SUB-COMMITTEE ON STABILITY AND LOAD LINES AND ON FISHING VESSELS SAFETY
55th session
Agenda item 9

SLF 55/INF.X
XX November 2012
Original: ENGLISH

DEVELOPMENT OF PROVISIONS TO ENSURE THE INTEGRITY AND UNIFORM IMPLEMENTATION OF THE 1969 TM CONVENTION

Information collected by the Correspondence Group

<u>Issue 1.b - Determining Least Moulded Depth (LMD)</u> (SLF 53/5, annex 4, issue No. 1) The term "least moulded depth", which is the basis for the length assignment, is undefined, and various interpretations of the term can lead to length dimensions varying on the order of 5% or more.

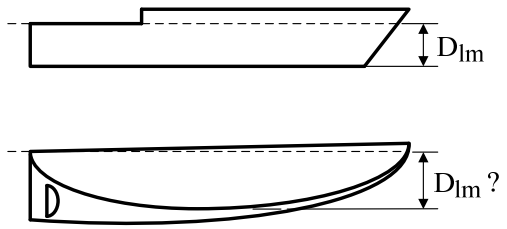
Questionnaire Responses Many different views were expressed on the various proposals. Most agreed, or agreed subject to changes, with the proposal to use the smallest depth along the length of the ship, with two respondents disagreeing on the grounds that the approach does not satisfactorily address configurations like those depicted in the lower of the two figures above, while several respondents made suggestions along the lines that in such cases, the least moulded depth could be taken at or near amidships. Another recommended using a tangent line approach instead, that takes into consideration raked straight keels, but with the moulded depth taken amidships in cases of curved keels. Two respondents highlighted differences between the TM Convention and Load Line Convention definitions related to least moulded depth, including the definitions of the upper and freeboard decks, with a third noting that the Load Line Convention also lacks a definition of least moulded depth, and a fourth describing a harmonization approach used by an Administration that could be applied, even for RO-RO ships, to arrive at consistent treatment. Several cited the need for illustrative figures.

Proposals The group considered six proposals. One proposal recommended taking the length measurement at the underside of the upper deck in cases where it is not possible to establish a minimum depth due to a curved keel. Two proposals recommended, in effect, that the least moulded depth be defined as the smallest moulded depth along the length of the ship (i.e., measured from the top of the keel to the upper deck). One proposal recommended that the least moulded depth be taken as the vertical distance between the top of the keel at its lowest point and the underside of the upper deck at its lowest point. One proposal recommended using the Load Line Convention moulded depth definition for ships with inclined keels.

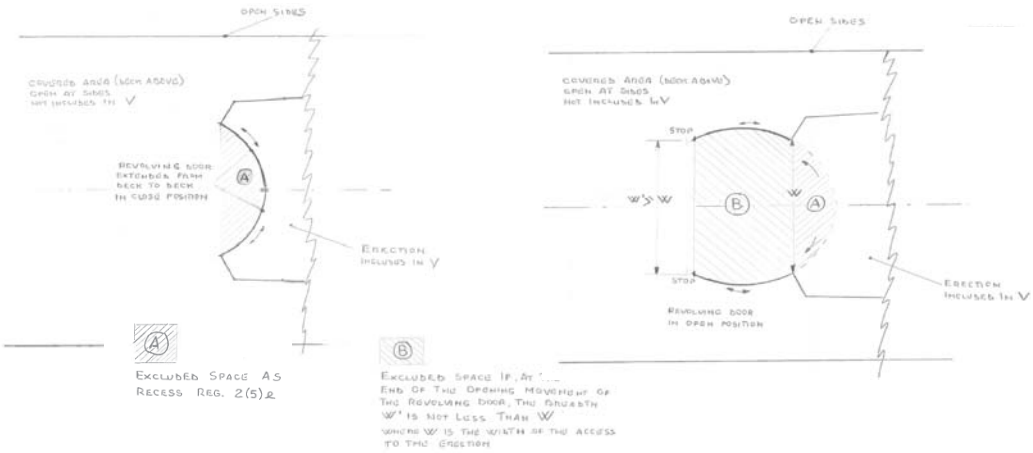
<u>Issue 3.i - Moveable Door Assembly Within a Covered Space</u> (Round 1) In applying excluded space provisions to a movable (i.e., retractable/revolving) door assembly that is within a covered space open on the side, it is unclear as to whether the door assembly itself is considered to be a partition that bounds enclosed space, or otherwise affects the exclusion of the surrounding space. In this case, the assembly extends from deck to deck. Figure A (left) shows the revolving door in the closed position. Figure B (right) shows the moveable door assembly in the open position, effectively creating the new space B, which covered and protected on its sides.

Questionnaire Responses A majority of respondents disagreed with the proposal, with one respondent expressing the view that the doors are, in fact, partitions. Another took issue with the characterization of space A as a recess in a boundary bulkhead, expressing the view that the door assembly does not constitute a bulkhead. This respondent provided a history of development of the language at the TM Convention, observing that the adjective “portable” originally applied only to the word “partition”, with “bulkhead” added later, and commenting that it remains unclear as to whether the adjective applies to both bulkheads and partitions. One respondent agreed with the exclusion of A but not B, as B extends into the deckhouse in excess of the one-half the width criterion, which equals W in this case.

Proposals The group considered a single proposal, recommending that if the breadth (W') at the maximum opening movement of the moveable door assembly is not less than (W), the width of the access to the erection, the spaces A and B are not included in tonnage, this is based on the assumption that the doors are not portable partitions or bulkheads.

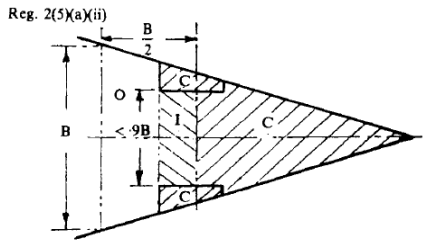
<u>Issue 3.j - Enclosed Space Versus Excluded Space</u> (CG Round 1) The TM Convention is inconsistent in how it describes and treats spaces that are excluded from tonnage. The Convention states, in effect, that “excluded” means “excluded from the total volume of all enclosed spaces (V)”. However, associated figures indicate that “excluded” means “not enclosed”. It appears that the labeling in the figures (“O” (for “Open”), “C” (for “Closed”) and “I” (for “Included”)) derive from that used in Proposals A & C discussed at the 1969 Tonnage Conference, which eventually became the basis for the gross tonnage measurement system of the Convention, but which did not use the term “excluded”.

Questionnaire Responses A majority of respondents agreed in principle with the first proposal, with one commenting that the matter could be satisfactorily treated through interpretations and another suggesting that the term “excluded” be interpreted as “enclosed but excluded”. Most agreed with the second proposal, with no disagreement, although two respondents expressed preference for addressing the matter through interpretations. Another respondent expressed the view that an interpretation cannot supersede a provision of the TM Convention, and that the text and figures in the Convention need to be amended accordingly.

Proposals The group considered two proposals. One proposal recommended establishing the interpretation that an excluded space is an enclosed space in all cases, and revising the Appendix 1 figures accordingly if the TM Convention is amended for other reasons. A second proposal recommended, if there is agreement, to amend the TM Convention with a broader definition with details on how to identify and address excluded spaces, knowing that in all cases such spaces are “indoors” (enclosed).

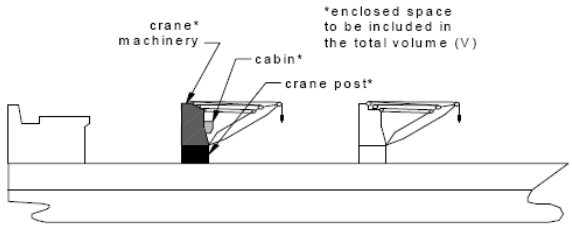
<u>Issue 3.k - Mobile Cranes</u> (CG Round 1) A clear definition of the term “mobile” as used in TM.5/Circ.5 should be given, as the term can lead to misunderstandings. A generally-accepted definition of mobile crane is one that is easily moved from one location to another. For cranes like the one shown in the picture below, the upper part rotates around its own axis; it does not actually “move” from its location.

Questionnaire Responses There was little agreement on the proposal. A respondent who agreed, with changes, recommended establishing a detailed definition of mobile crane along the lines of a machine mounted on a non- or self-propelled, crawler- or wheel-mounted, mobile base, that is capable of travelling over a supporting surface without the need for fixed runways. One respondent who disagreed commented that machinery, meaning revolving cranes, movable loading/unloading equipment and other similar items or structures, should not be

included in tonnage. Another expressed the view that crane structures, regardless of type, should be included in tonnage. Another questioned why the term “mobile crane”, rather than a more generic term, is used, citing the example of a spreader beam for a heavy lift ship, which is portable, but stowed on deck.

Proposals The group considered a single proposal. The proposal recommended that only those cranes of a type which displace from one point to another (e.g., gantry cranes) should be exempted (i.e., not included in tonnage).

Issue 3.m - Spaces Fitted to Outer Structure Boundary (CG Round 1) Clarification is required regarding treatment of the part of a mast, air trunk and other similar space fitted to the outer surface of a structure’s boundary.

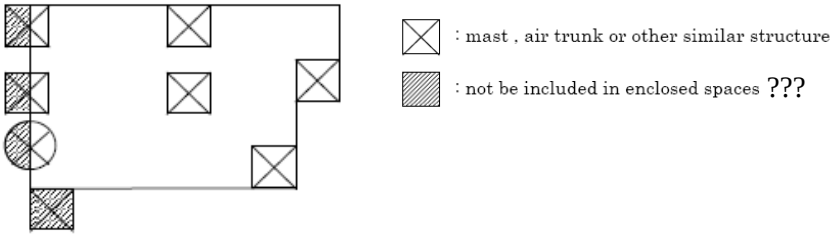
Questionnaire Responses An equal number of respondents agreed, or agreed with changes, as disagreed with the proposal. Three respondents commented that per the paragraph 4.6 interpretations of TM.5/Circ.5 (Regulation 2(4)), spaces not separated on all their sides should be included in tonnage. Another respondent expressed preference for removing the sectional area criterion from the existing interpretations altogether to avoid impacts on ship designs, but recommended that the proposal be modified to take the cross-sectional area in a direction perpendicular to its longitudinal axis, should this view not prevail.

Proposals The group considered a single proposal. The proposal recommended that the part of a space fitted to the outer surface of a structure’s boundary having at least three exposed sides and having the largest cross-sectional area in the longitudinal direction of the structure not exceeding 1 m^2 should not be included in tonnage.

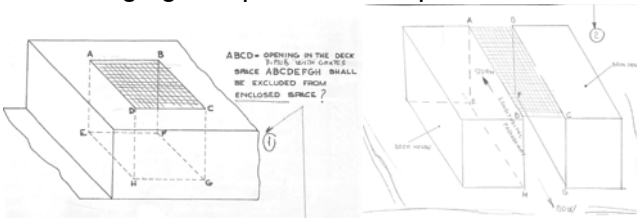
<u>Issue 4.e - Fitting of Grates Over Deck Openings</u> (CG Round 1) Spaces that can be excluded in accordance with Regulation 2(5)(d) are frequently fitted with grates (e.g., in order to allow crossing). Also longitudinal passageways between deck houses are sometimes fitted with grates on the top. The following figures provide examples of this kind of arrangement.

Questionnaire Responses There was little agreement on the proposal. One respondent agreed that a grating could constitute a means of closure, such that the space ABCDEFGH in the left hand figure cannot be excluded, but that a grating is not a deck, and therefore the space ABCDEFGH in the right hand figure is not an enclosed space. Two respondents expressed views along the lines that grates may not constitute partitions or decks, and if this is the case, the presence of a deck grate should not cause the space below to be included in tonnage. Another respondent commented that the presence of grates whose only purpose is to provide safe access and prevent risk of injury to crew members should not change the status of the space.

Proposals The group considered a single proposal, recommending that deck grates be considered as providing a means of closure under regulations 2(5)(d). This would preclude any space below from exclusion from tonnage.

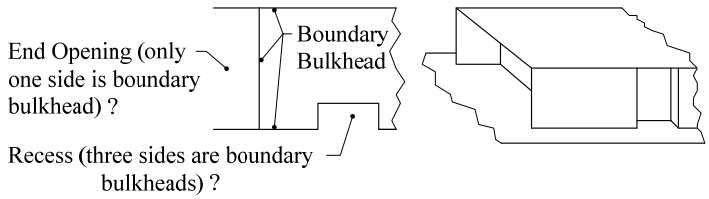
Issue 5.c - Excluding Space Opposite an End Opening as a Recess (SLF 53/5, annex 4, issue No. 17) If an opening in the end of a structure is treated as a "recess" under Regulation 2(5)(e) instead of a "space opposite an end opening" under Regulation 2(5)(a), up to twice the amount of space may be excluded. Various approaches have been used to address this issue, including the establishment of definitions for the term "boundary bulkhead" that would preclude treatment of a "typical" end opening as a recess. Clarification would be helpful to ensure consistency and avoid misuse.

Questionnaire Responses A majority of respondents agreed with all of the proposals. The proposal receiving the most support was the one recommending that three boundary bulkheads along with a deck above be considered as necessary conditions for bounding a recess. One respondent expressed support for the linkage to boundary bulkheads, but disagreed with the stipulation for three, instead of two, bulkheads without amending the TM Convention to revise Figure 10. Along similar lines, another respondent cited the need to amend the TM Convention to implement this proposal, and commented to the effect that Figure 10 illustrates a "real" two-sided recess. Among the other comments provided, one respondent expressed the view that a recess extending for more than one tier should be not included as enclosed space. Another respondent commented that Regulation 2(5) should be expanded in the context of applying recess provisions, to ensure that gross tonnage is reflective of overall size. Another commented that certain open spaces whose purpose is simply to provide protection for the crew should not be penalized (i.e., by including them in tonnage).

Proposals The group considered seven proposals. Three proposals recommended that a recess be defined in terms of a space bounded on three sides by boundary bulkheads, with one of these proposals recommending an additional condition that a recess also be bounded by a deck above, on the basis that otherwise the space would not considered enclosed, and a second recommending that qualifying side recesses be addressed. Another proposal recommended that a recess be defined in terms of space bounded on at least two sides by boundary bulkheads, and offered a definition of the boundary bulkhead along the lines of a bulkhead separating an enclosed interior space from the surrounding weather. One proposal citied Figure 10 of Annex 1 of the TM Convention, and questioned whether the two boundary bulkheads shown in the right hand portion of the figure, in fact, bound a "real" recess, and if not, whether three boundary bulkheads should be required. Another proposal offered a number of diagrams to be used in evaluating a variety of spaces, including recesses, reflecting views offered at an international meeting of tonnage experts held in 1990. The remaining proposal recommended that a recess opening be considered to extend from deck to deck notwithstanding the fitting of a curtain plate of a depth not exceeding by more than 25 millimeters the depth of the adjoining deck beams.

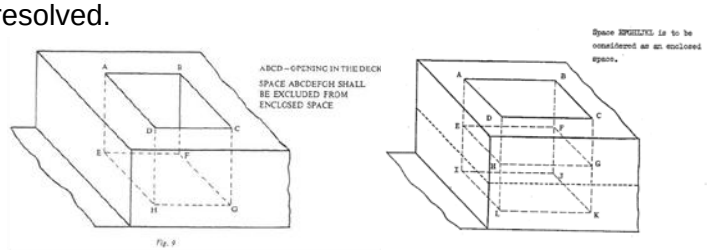
<u>Issue 5.f - Restrictions on Excluding Space Below Uncovered Openings</u> (SLF 53/5, annex 4, issue No. 20) The text of Regulation 2(5)(d) and the accompanying figure leave it unclear as to the extent to which a space "immediately below" a deck opening may be excluded. A question along these lines was raised by a flag State in document SLF 29/10 (3 November 1983), but was not resolved.

Questionnaire Responses Most disagreed with the proposal that applied the one-fourth the breadth criterion. There was little agreement on the remaining proposals, other than the

Proposals The group considered six proposals. Two proposals made recommendations along the lines of defining "immediately below" as extending to the next complete structural deck underneath the deck with the opening, with both indicating the need for a definition of "structural deck", and one recommending inclusion of a supporting diagram. One proposal recommended that the space lettered ABCDEFGH should be construed as "immediately below", while another, citing discussions at SLF 29, recommended that the space lettered ABCDLIJK should be similarly construed. Another proposal recommended establishing the interpretation that "immediately below" means to a depth not exceeding the distance to the deck below, or one-fourth the breadth of the ship, whichever is less. Another simply recommended better documentation.

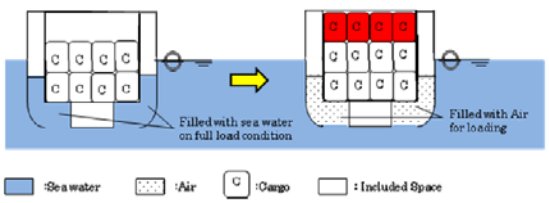
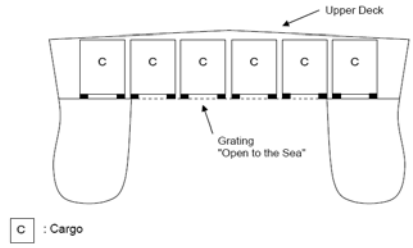
<u>Issue 6.d - Large Volumes of Spaces Open to the Sea</u> (SLF 53/9/5) Some ship designs have been developed to obtain additional buoyancy or an additional cargo capacity with no increase in the gross tonnage, making use of the open to the sea provisions regulation 6(3) to effectively reduce the ship's gross tonnage. Examples of such designs are: 1) ships with open bottom spaces between the inner skin and outer shell that hold air to gain additional buoyancy (figure 1); and 2) ships with cargo spaces between cross-deck structures with gratings openings to the sea (figure 2). The volumes of such spaces can be substantial, relative to the total volume of the ship.

Questionnaire Responses Most respondents either agreed with all of the proposals, or agreed subject to changes. In commenting on the proposal regarding free communication with the sea, one respondent cautioned that the language must address stern chutes and hawse pipes. Another respondent stated agreement in principle with this proposal, subject to including the provision that a space open to sea may not be excluded if used for the carriage of cargo, and noting that this approach would address situations where trapped air could prevent water from entering a tank. Another respondent expressed the view that there should be no linkage between exclusion of a space as open to sea and whether or not the space is buoyant or carries cargo or stores.

Proposals The group considered four proposals. Two proposals recommended the interpretation along the lines that spaces open to the sea, used or appropriated for holding cargo, and/or contributing to the buoyancy of the ship, should be included in tonnage. One proposal recommended the interpretation that the space must be in free communication with the sea at all times. The remaining proposal recommended that tonnage not be calculated with respect to the use of a space, but that spaces that are not always open to sea or are fitted with a means for securing cargo cannot be excluded.

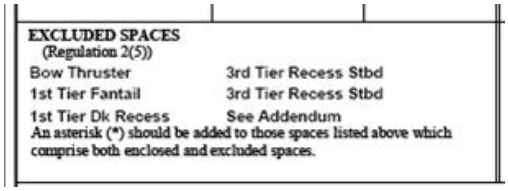
<u>Issue 9.c - Listing Excluded Spaces on the Certificate</u> (SLF 53/5, annex 4, issue No. 6) The reverse side of the ITC69 form provides a space for listing excluded spaces, but lacks sufficient room for specifying all excluded spaces on larger ships of complex design (e.g. cruise ships). Nor is it clear that the mere listing of an excluded space provides sufficient information to permit meaningful verification without access to associated tonnage calculations. Finally, space limitations on the form, and confusion regarding the need to even list excluded spaces, has resulted in different approaches among flag States, ranging from the attachment of addenda to the ITC69, to omitting reference to the spaces altogether.

Questionnaire Responses A majority of respondents disagreed with the proposal to provide sufficient detail to permit verification, and there was little agreement on any of the other proposals. One respondent expressed the view that interpretations to not list excluded spaces on the ITC69 could be used in lieu of amending the TM Convention if there was agreement on this matter. Another respondent expressed the view that Article 9(2) does not limit the size of the blocks on the ITC69 or the number of pages, as long as the ITC69 contains all of the required information. Another respondent suggested using addenda to the ITC69 to capture the excluded space information if the excluded space block is deleted, and that detailed information on excluded spaces could be provided on the calculation sheets for use during flag transfer. Another respondent expressed the view that excluded spaces should be identified in the calculations. Another commented that further consideration needs to be given to the appropriate documentation and recording of calculations and associated ITC69 information with respect to excluded spaces.

figure 12 Unified Interpretations Proposal 5.c.1

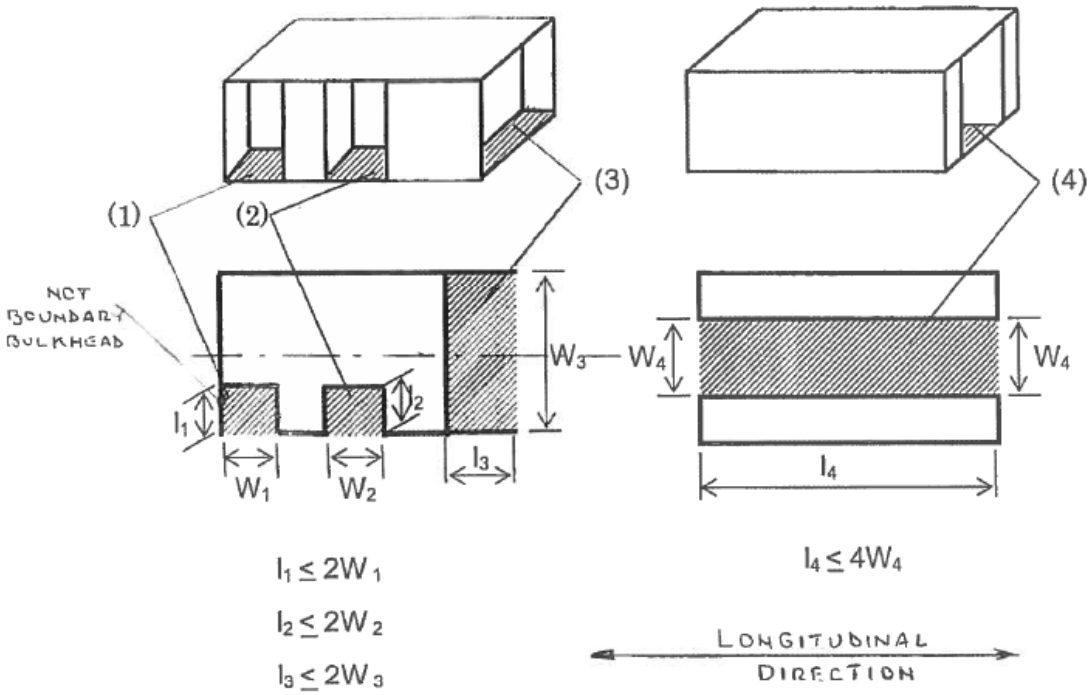
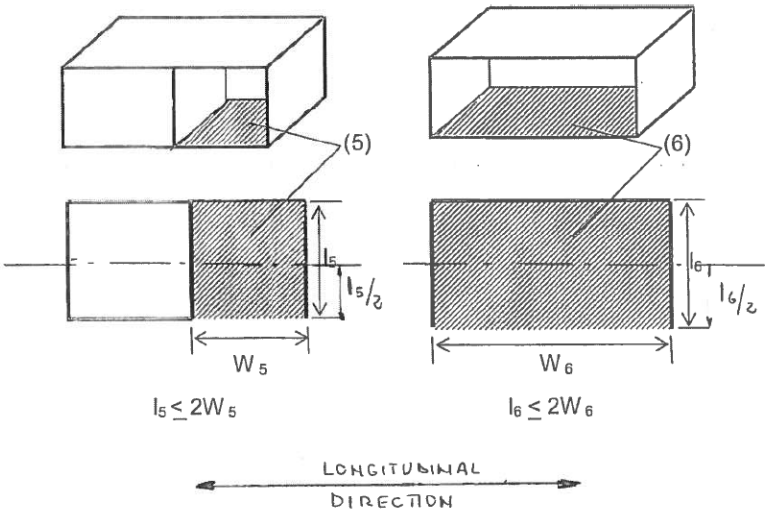
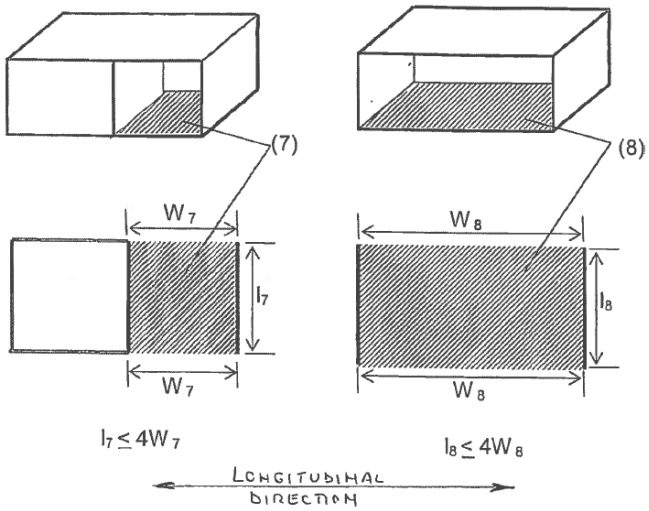
(1) It is not a recess – Bounded by only two boundary bulkheads –
It should be excluded due to the side opening.

(2) It is a recess – Bounded by three boundary bulkheads –
It should be excluded.

(5) It is not a recess – Bounded by only one boundary bulkhead –
Should be excluded a space limited inboard from the side opening to one-half of the breadth of the erection ($l_5/2$), due to the only one side opening.

(6) It is not a recess – There are not boundary bulkhead –
Should be excluded a space limited inboard from the side opening to one-half of the breadth of the erection ($l_6/2$), due to the only one side opening.

(7) It is not a recess – Bounded by only one boundary bulkhead –
Should be entirely excluded due to the two sides opening.

(8) It is not a recess – There are not boundary bulkhead -
Should be entirely excluded due to the two sides opening.
